Safety Recall 13S12 – Supplement #3

All 2013 Model Year Escape Vehicles Equipped with a 1.6L Engine
Risk of Localized Overheating of the Engine Cylinder Head that May Lead to Oil Leak
Fires

New! REASON FOR THIS SUPPLEMENT

- Provide additional repair instructions and part information to replace the Turbocharger Inlet Pipe on vehicles built from Job #1 through June 27, 2012.
NOTE: Replacement of the Turbocharger Inlet Pipe on affected vehicles is not related to engine overheating or oil leak concerns. Replacement of the Turbocharger Inlet Pipe on affected vehicles previously repaired under 13S12 is not required.
- Remind dealers that all parts are available through normal ordering channels.

FIGURE A3

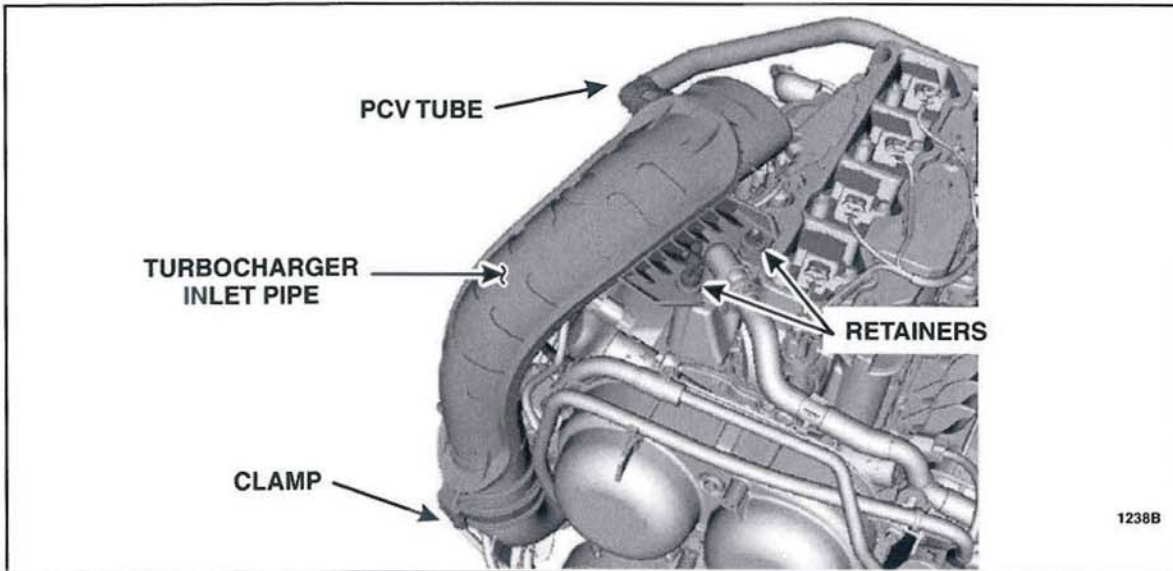
NOTE: For vehicles built on or before June 27, 2012 having a turbocharger inlet pipe with resonator chambers, discard the turbocharger inlet pipe. See Figure N1 in Procedure N, Page 52 of 55.
